# PLANNING COMMISSION MEETING

3. 25-051 MOD - Major Modification request for the Deer Pointe Basketball Court Structure

<b>DATE OF MEETING:</b>	January 12, 2026
<b>FILE NO.:</b>	25-051 MOD
<b>PROJECT NAME:</b>	Modification to Planning Commission Final Decision & Removal of Cupola Requirement
<b>APPLICANT/OWNER:</b>	Tiana Rundell/City of Sandy
<b>ADDRESS:</b>	18200 Meadow Drive
<b>MAP/TAX LOT:</b>	25E18CC 13400 and 25E18CD 01600
<b>SIZE OF PROPERTY:</b>	3.16 acres
<b>ZONING:</b>	Parks and Open Space (POS)
<b>STAFF CONTACT:</b>	Patrick Depa, Senior Planner

**Request:** Modification to Planning Commission Final Decision – Removal of Cupola Requirement

(Figure 1)

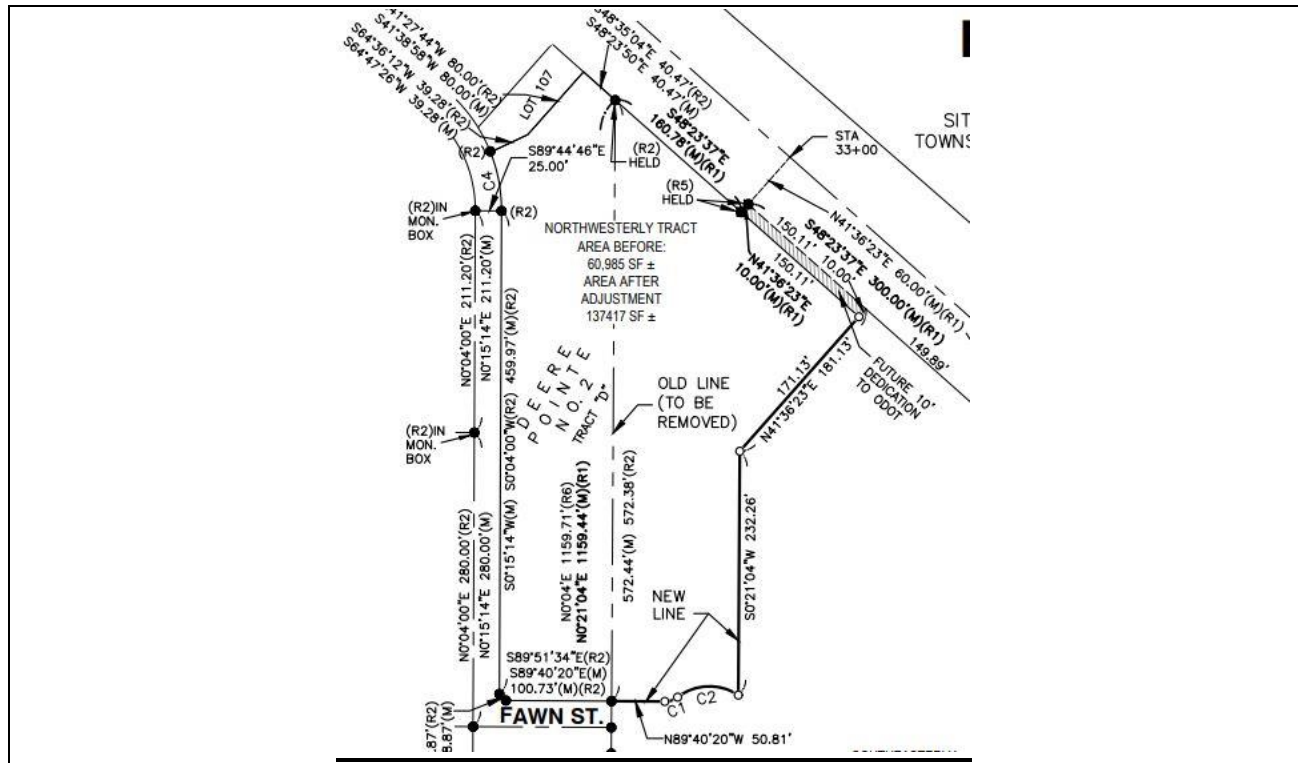
**Finding 1.** The placement of the basketball court crosses the common property line and several walkways meander between parcels to other park structures and amenities. The applicant submitted a Property Line Adjustment application (File No. 25-002 PLA) along with a draft survey to combine the two parcels. That application was approved with conditions by the Planning Division on February 26, 2025. **The applicant shall record the property line adjustment associated with File No. 25-002 PLA prior to issuance of the certificate of occupancy for the basketball shelter (see Figure 1).**

(Figure 2)

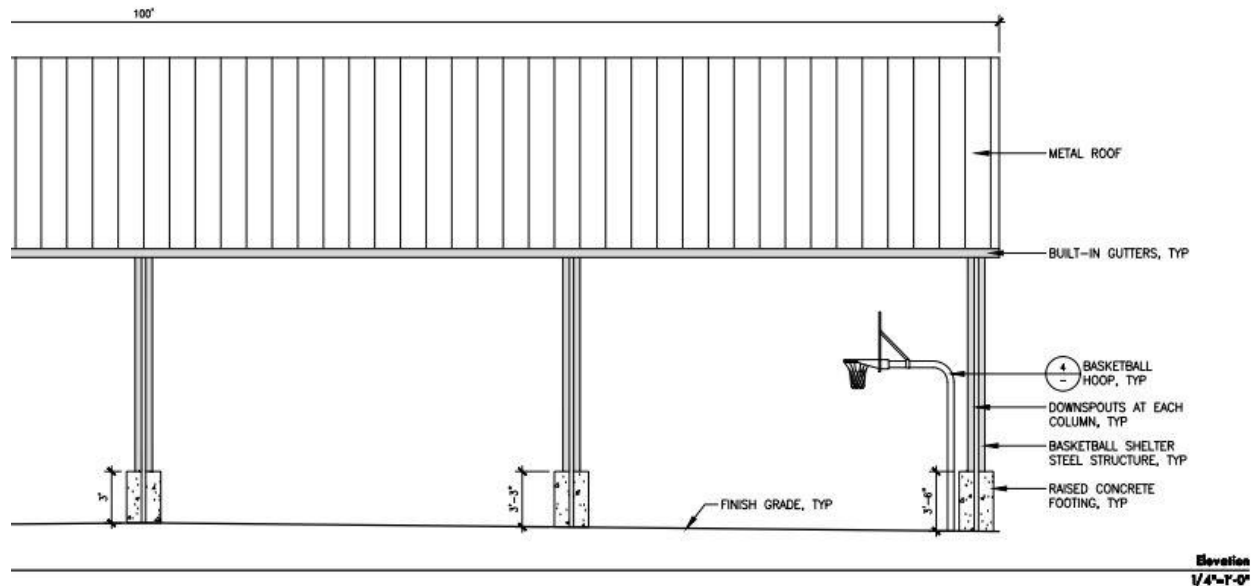
**Finding 8.** The basketball court shelter has a similar open-air design (no walls) as the proposed picnic shelter already approved for the park. However, where the picnic shelter has steel columns wrapped in stone that meet the above requirement to include strong base materials such as natural stone, split-faced rusticated concrete block, or brick, the basketball court shelter columns are not proposed to include such materials. The columns on the basketball court shelter are proposed to be steel but, will be set in a raised concrete base/footing (see Figure 2). The exposed footings are proposed at 36-inches in height in standard grey concrete, but without a stone wrap. This requires a variance to Section 17.90.120.B.3.b. The applicant applied for a Type III Special

The open gable ends are comprised of painted metal decorative beams with a Howe style truss at both ends of the structure (see Figure 3). Neither gable end faces a street but both ends fall short of satisfying the requirement to include at least three “Sandy Style” design features. The materials used in the gable ends of the shelter can be modified to meet the requirements of this subsection and the number of design elements needed to meet the intent of this section.

(Figure 3)

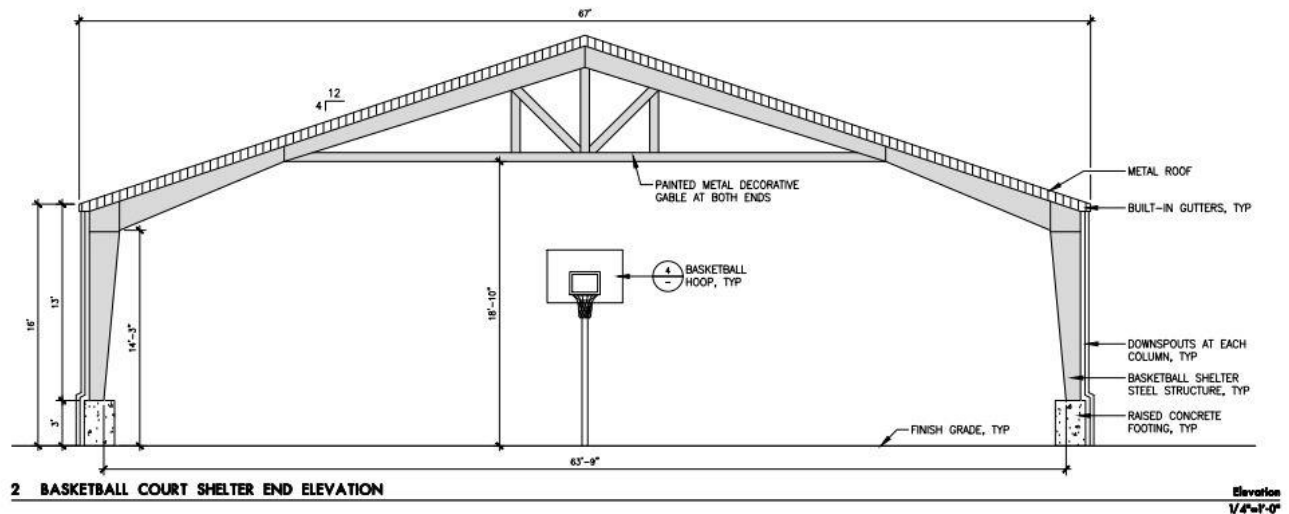
At the quasi-judicial public hearing on July 28, 2025, the Planning Division recommended that the applicant apply a dark base coat of paint on the exposed beams and brush on a different lighter color with a grain roller to achieve a wood style finish. The Planning Commission discussed the merits of the staff recommendation but had concerns about how the wood style finish would appear on steel I-beams and were also concerned about graffiti. However, the Planning Commission decided that painting the I-beams one solid color and painting the wood grain on the gable ends would be required. **The applicant shall submit details on the painted-on wood grain for the gable ends. Also, the Planning Commission conditioned the installation of multiple heavy metal brackets at all connection points in the two gables to replicate a Sandy Style design and finish.** This is also emphasized under *Finding 27*.

**Finding 9.** The applicant has identified the proposed finish for the metal roof, roof trim, and downspouts as Cypress Green by Metallion Industries. The columns and decorative gable ends are proposed to be painted with Miller Paint "Film Noir"(0144). Film Noir is not in the historic color collection. **The applicant shall choose a color from the Miller Paint Historic Color Collection to replace Film Noir for staff review and approval.**

The proposed natural wood color on the gable ends and the forest color metal roof will be consistent with the colors assigned to the proposed picnic structure. The raised concrete bases are proposed as typical concrete grey. **The color of the metal roof is compatible with the historic colors in the City of Sandy Color Palette but the applicant shall pick a color from the Miller Paint collection to replace "Film Noir"(0144).**
